**THE HIGHLAND COUNCIL**

**SOUTH PLANNING APPLICATIONS COMMITTEE –  
20 MAY 2014**

**14/01282/MSC – Highlands and Islands Enterprise and University of the Highlands and Islands.**

**Land at Beechwood Farm, Inverness (Inverness Campus)**

Title **LANDSCAPE LAYOUT**

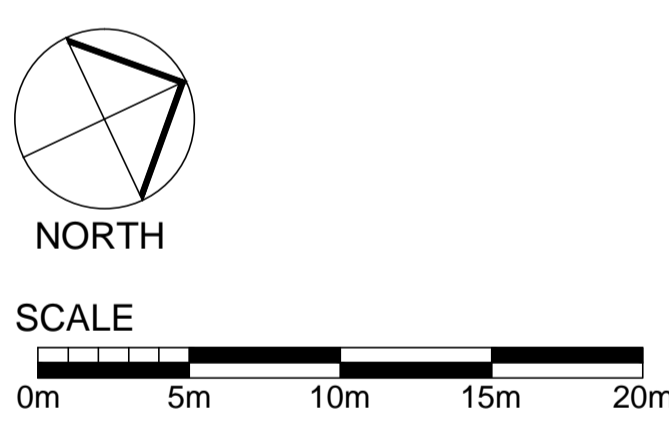
- 6.10 Landscaping treatment is relatively simple, with a combination of mown and wild grass areas and hard landscape finishes interspersed with hedging/shrubs and trees. The paving will include sections of Caithness stone. Trees species selected include European Oak, Alder, Poplar and Rowan. These species are appropriate to the site.

TITLE  
**Coloured Elevations  
North & South Elevations**

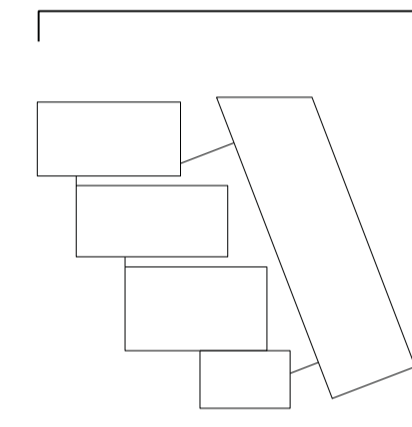
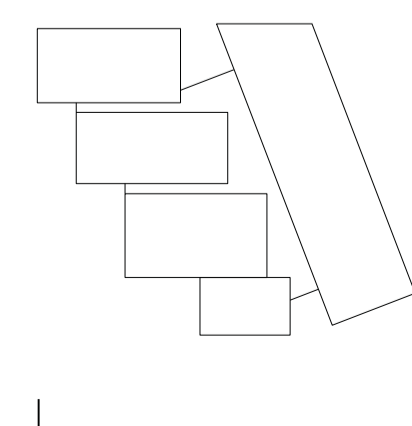
- 6.6 In terms of detailed design, the three storey office block will have a glazed façade to the front elevation with a roof and upper three quarters of the walls on both the north and south elevations clad in raised profile pre-patinated copper sheeting. The first floor level on these elevations will be clad in Caithness stone. The upper storeys of the rear elevation will be glazed with the first floor clad in Caithness stone. The massing of the block and materials on the north and south elevations is broken down by the use of a random glazing pattern. The positioning and fixing of these windows, that will utilise a combination of projecting, indented and flush fitting styles, will provide a reasonable degree of modelling to these elevations.
